Consolidation Coal Company
Western Region
2 Inverness Drive East
Englewood, Colorado 80112
(303) 770-1600

re: Emery Prep Plant Coarse Refuse Pile

RE: Consolidation Coal Preparation
Plant and Loadout Facility
Permit Review
ACT/015/015
Emery County, Utah

Exhibit #1

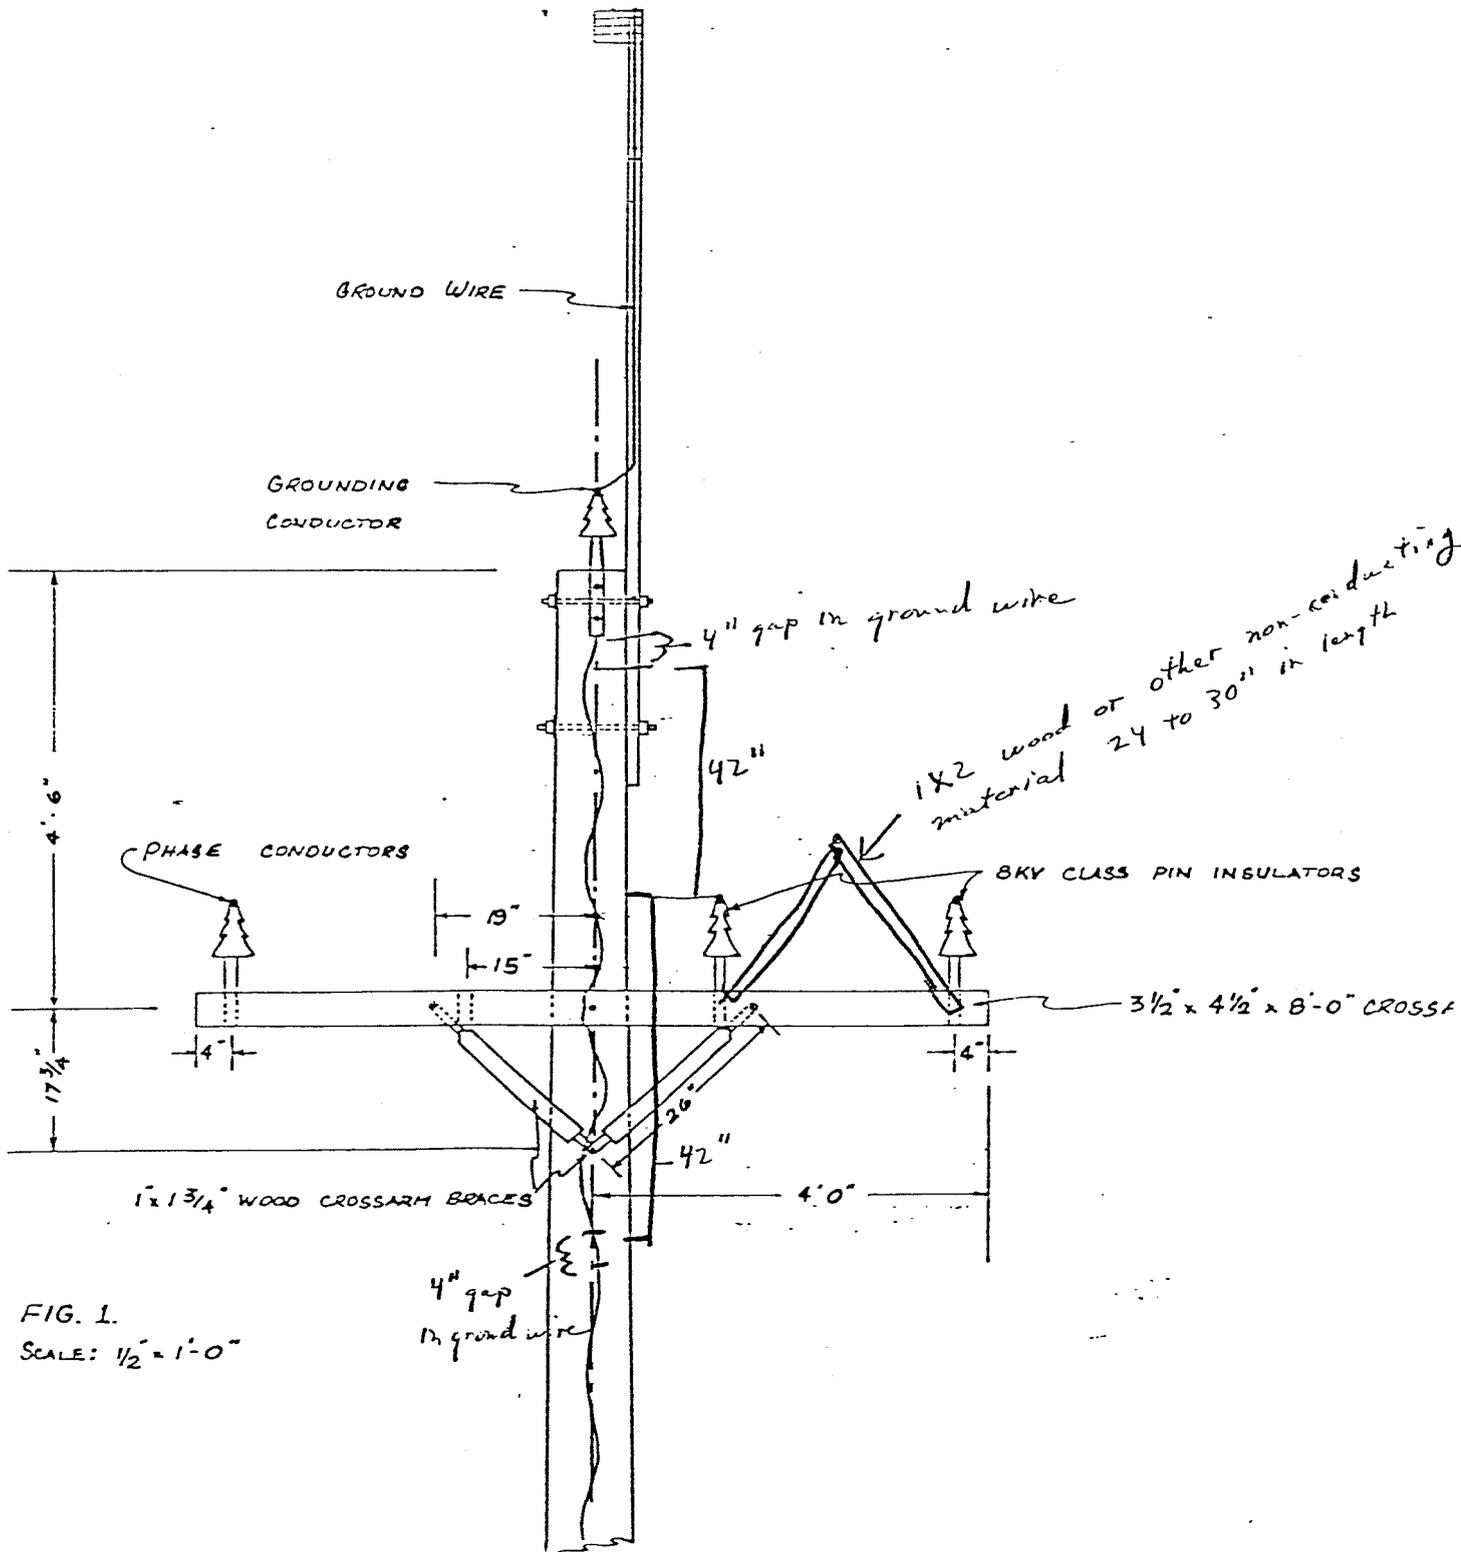
Although the perch design submitted on March 22, 1982, is illustrated in the REA Bulletin 61-10, its intended use is for single phase systems. It does not provide adequate protection on three phase systems.

I have enclosed as Exhibit #1, the necessary modifications to your proposal that would make your proposal acceptable. Also, Exhibit #2 shows other designs that would be acceptable as well.
